CAIRNGORMS NATIONAL PARK AUTHORITY

Title: REPORT ON CALLED-IN PLANNING APPLICATION

DEVELOPMENT PROPOSED: PATHWORKS, DYKING, LANDSCAPING AND ART WORKS AT CAIRNGORM MOUNTAIN CAR PARK (FULL PP)

REFERENCE: 06/258/CP

Figure 4 Artists sketch of viewpoint feature Will MacLean/Arthur Watson

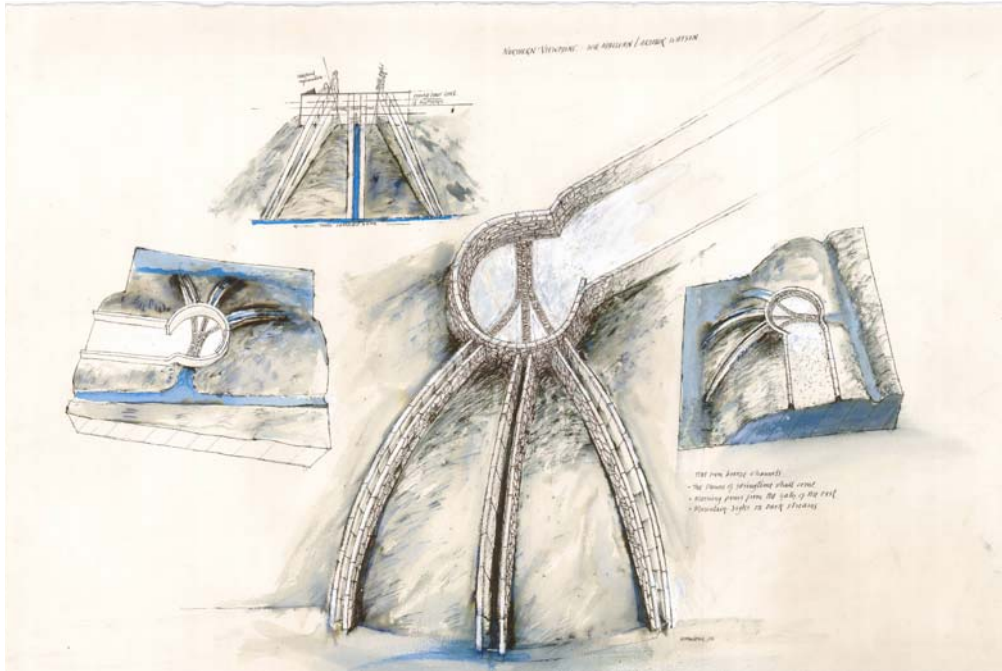
15. **SEPA** has no objection to the works subject to construction methods statement condition.
16. **CNPA Landscape Officer** has considered the application and some concerns are raised regarding the large geometric nature of the steps up to the all abilities footpath which seems at odds with the flowing nature of the surrounding landscape. The staircase is very grand and sweeping on plan and the precision of its geometry seems out of place with its surroundings. Similar concerns are raised regarding the viewpoint feature. Again the rills down which water will flow appear rather mechanical in design.

17. The drawings imply a construction that is very sharp and crisply detailed. The nature of local building material is the opposite consisting more usually of rounded stone washed and worn in glacial and fluvial deposits. Something more organic and flowing would suit local material better and be more in harmony with its surroundings. The detailing of the walls should allow for the natural irregularities of materials. If the scheme were to address these points then the dialogue between the artwork and its surroundings would be much more successful, the impact upon the landscape being wholly positive and it would make a good contribution to the area.

31. The most prominent feature is the viewpoint. The submitted engineering drawings portray a formal geometric structure which in line with the CNPA Landscape Officer initial comments would appear out of place with the surrounding landforms. Some design sketches have been prepared (see fig 4) which give a good appreciation of what is intended as opposed to the bare engineering bones of the structure. In principle, this element is providing a viewpoint feature at a point on the all abilities path that already effectively hosts a formal viewpoint, albeit less definitive than what is proposed here. The ability of the structure to transmit the sound of water underneath and running down the rills will be a significant addition for people who are visually impaired. The walls and the rills will be constructed in an irregular manner using local granite with areas in between being vegetated in accordance with the advice of SNH.

18. After a meeting with the artist and project manager CNPA Landscape Officer is supportive of the scheme and it is pointed out that the success of the project depends upon the level of workmanship. The latest sketch plans show that a much more irregular approach will be taken to the construction than at first appears the case from the engineering drawings. A maintenance and management agreement is suggested by planning condition to ensure that the landscaping is maintained in the future.
